PETITION TO AMEND INTERIM	)	Case No.: CCH-MA13-01
INSTREAM FLOW STANDARDS FOR	)	
HONOPOU, HUELO (PUOLUA),	)	OBJECTIONS, IN PART, OF
HANEHOI, WAIKAMOI, ALO,	)	MAUI TOMORROW TO
WAHINEPEE, PUOHOKAMOA,	)	HEARINGS OFFICER'S
HAIPIUAENA, PUNALAU/KOLEA,	)	AMENDED RECOMMENDATION
HONOMANU, NUAAILUA, PIINAAU,	)	RE INTERIM RESTORATION OF
PALAUHULU, 'OHI'A (WAIANU),	)	STREAM FLOW; EXHIBIT "A";
WAIOKAMILO, KUALANI,	)	MT EXHIBITS "1" – "40"; MT
WAILUANUI, WEST WAILUAIKI, EAST	)	MAPS "1" – "4"; CERTIFICATE
WAILUAIKI, KOPILIULA, PUAKEA,	)	OF SERVICE
WAIOHUE, PAAKEA, WAIAAKA,	)	
KAPAUULA, HANAWI and MAKAPIPI	)	
STREAMS	)	
	)

**OBJECTIONS, IN PART, OF MAUI TOMORROW TO HEARINGS OFFICER'S  
 AMENDED RECOMMENDATION RE INTERIM RESTORATION OF STREAM  
 FLOW**

**EXHIBIT "A"**  
**AMENDED CHART**  
**HANEHOI WATERSHED**

MT Map #4

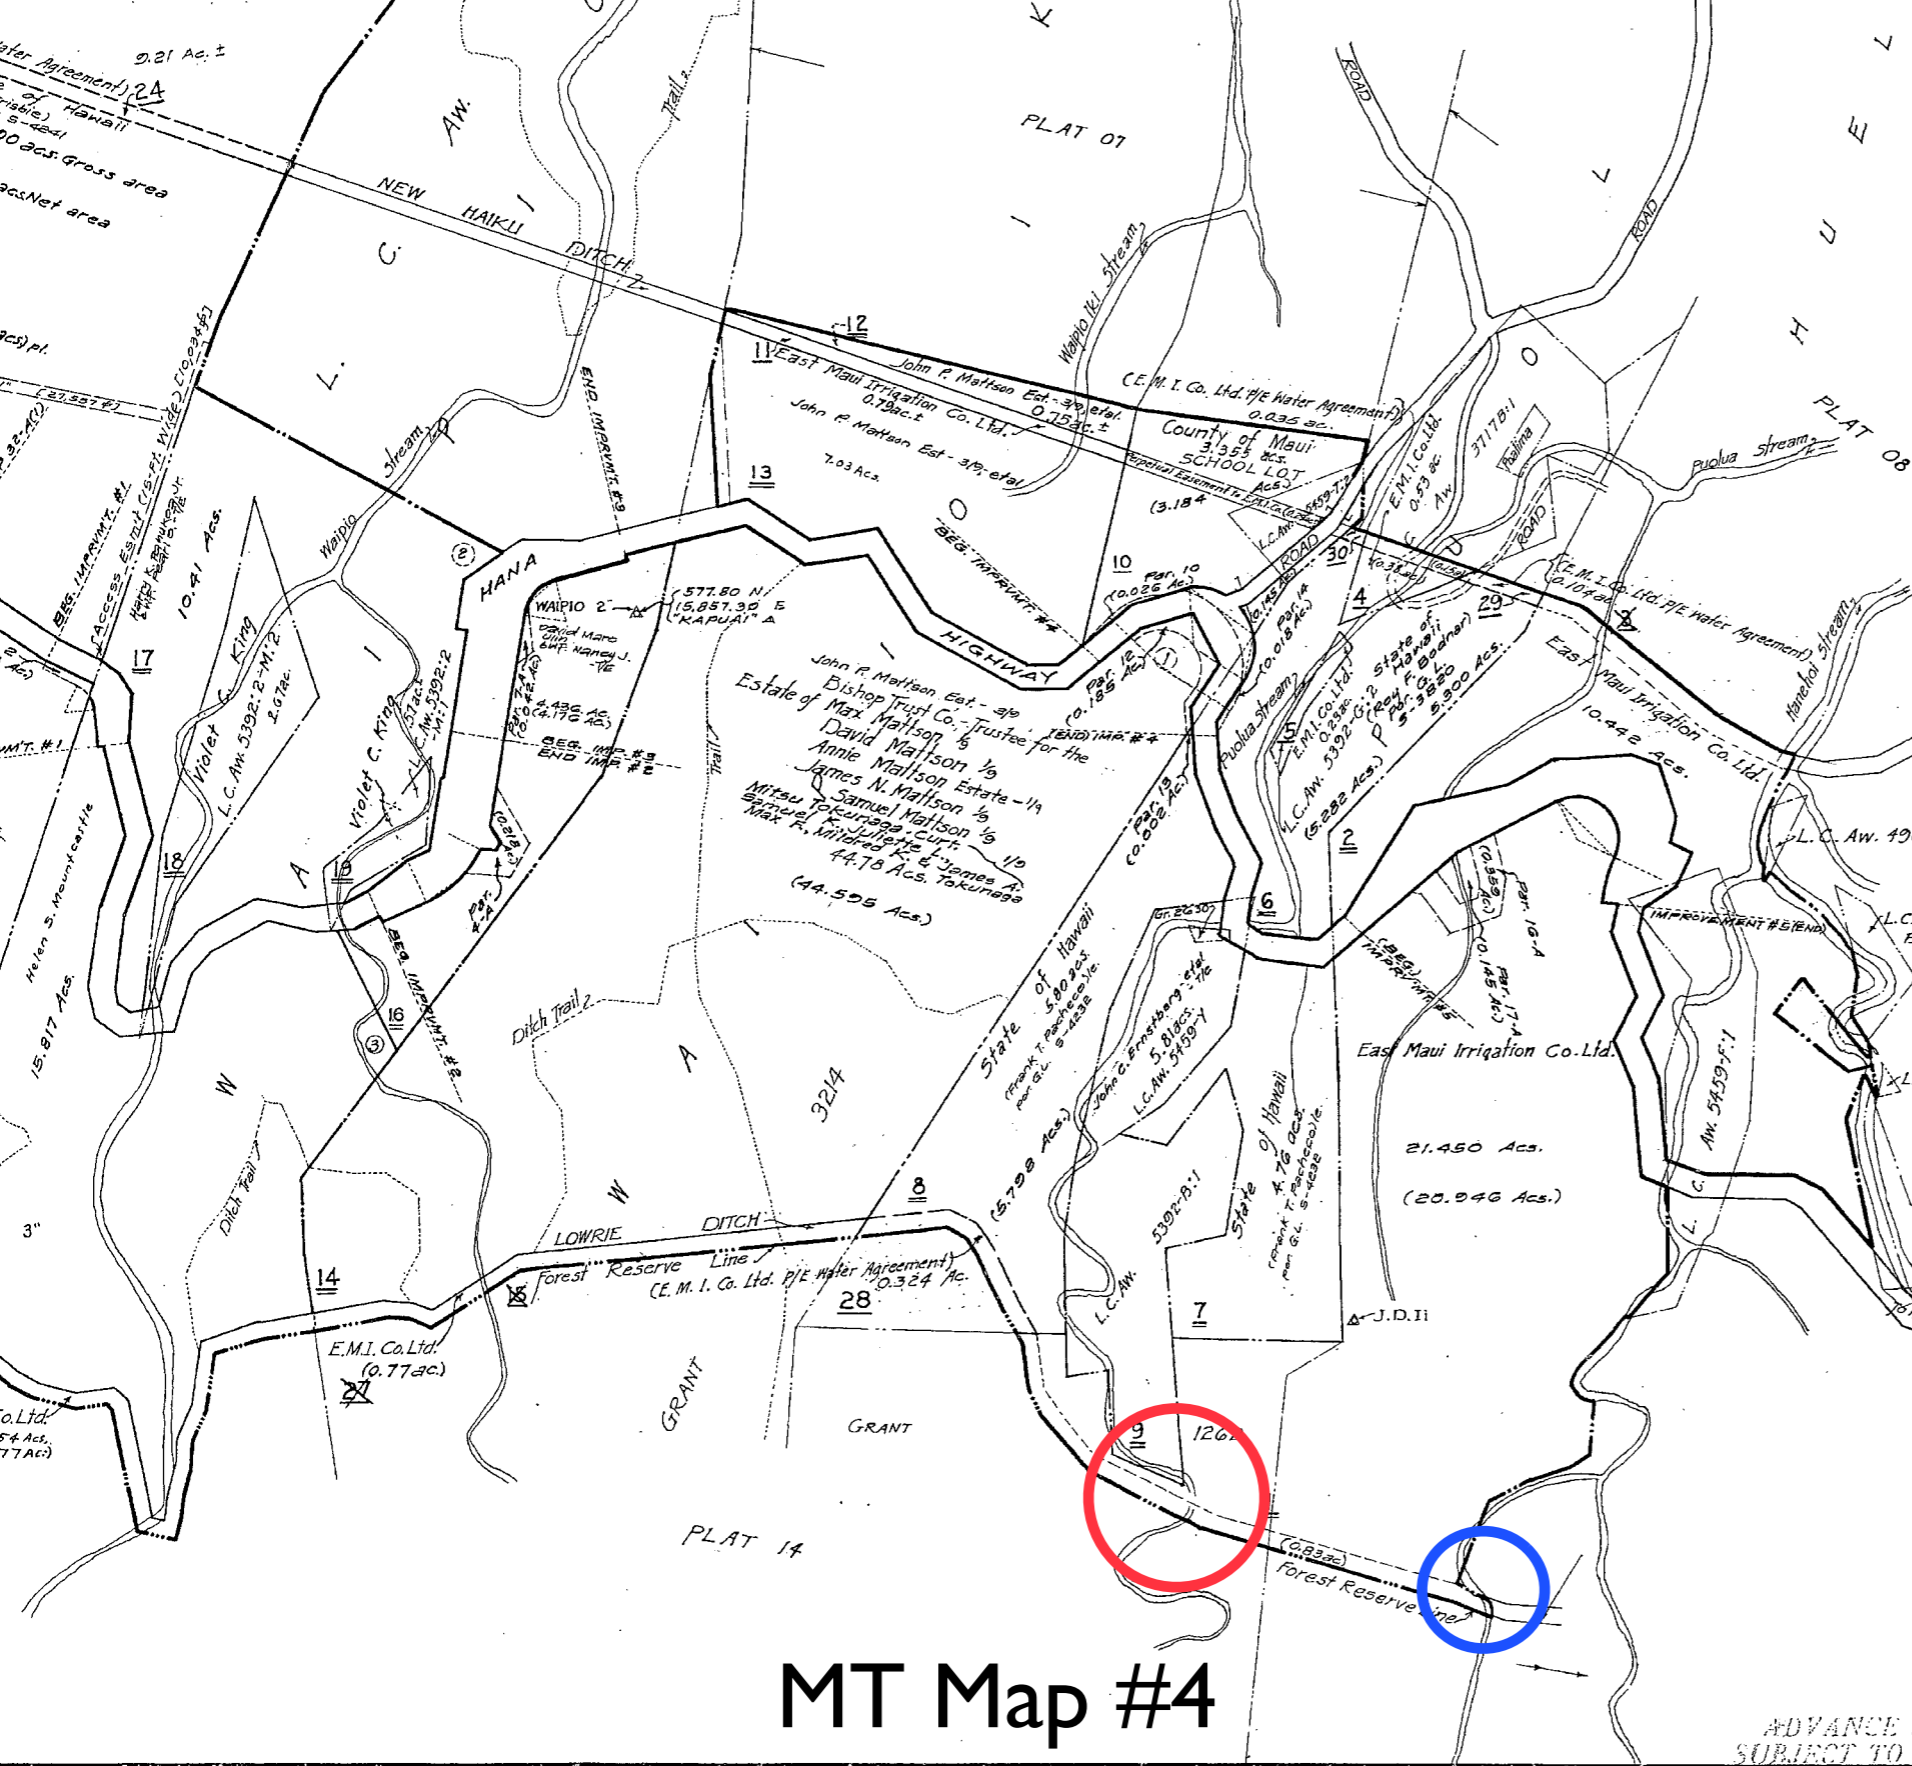
Huelo Stream Lowrie Intake 155.6 (L-7) (blue circle) is shown.

Puolua stream intake on Lowrie Ditch is circled in red.

They are two completely different streams with separate diversions

Huelo stream is not shown on CWRM maps but is on Plat maps and EMI maps

## Lowrie Ditch Diversion- Puolua Stream (L-7a) intake (March 2015)

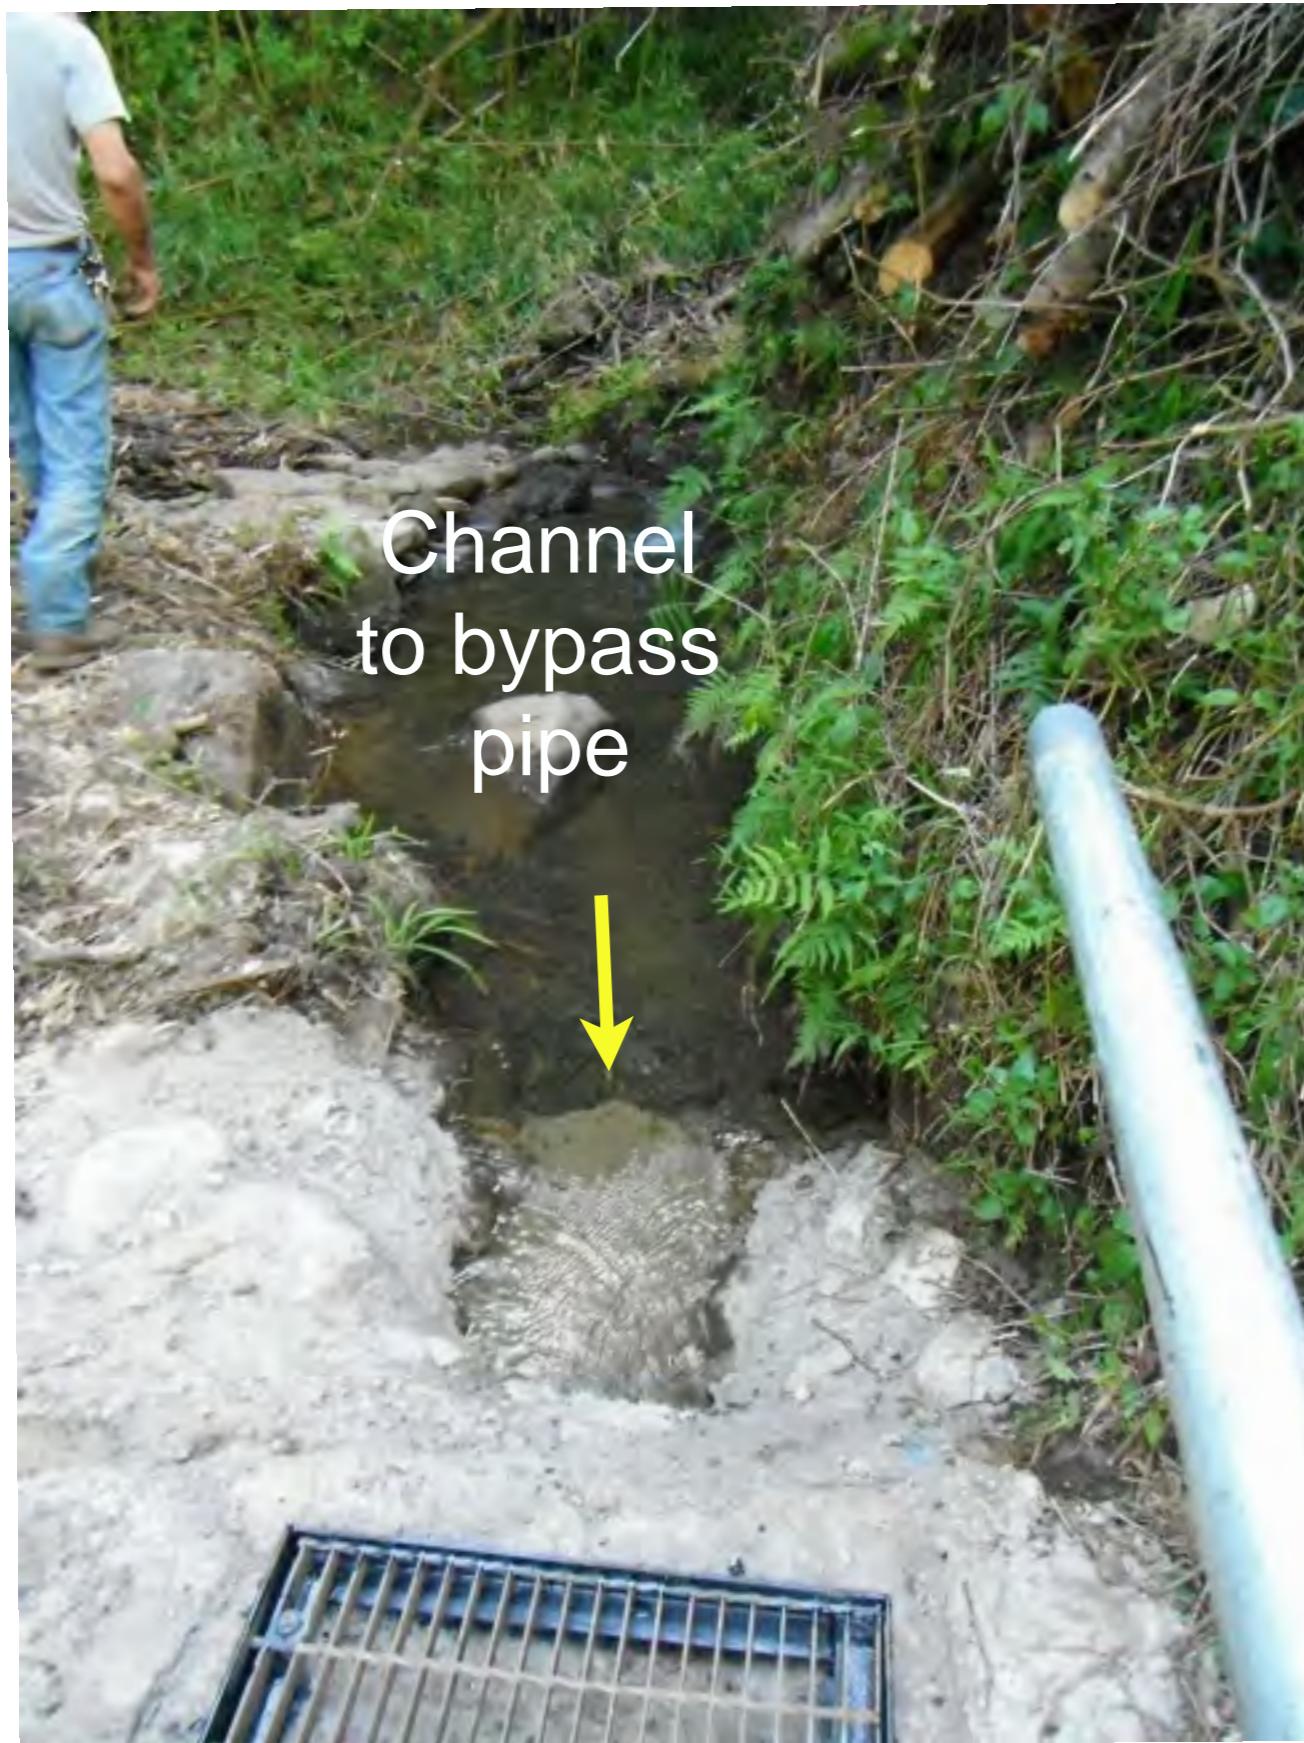
Lowrie Ditch flows under new 8" bypass pipe and into a tunnel. A dirt EMI service road runs along ditch, and Puolua stream continues makai of the road
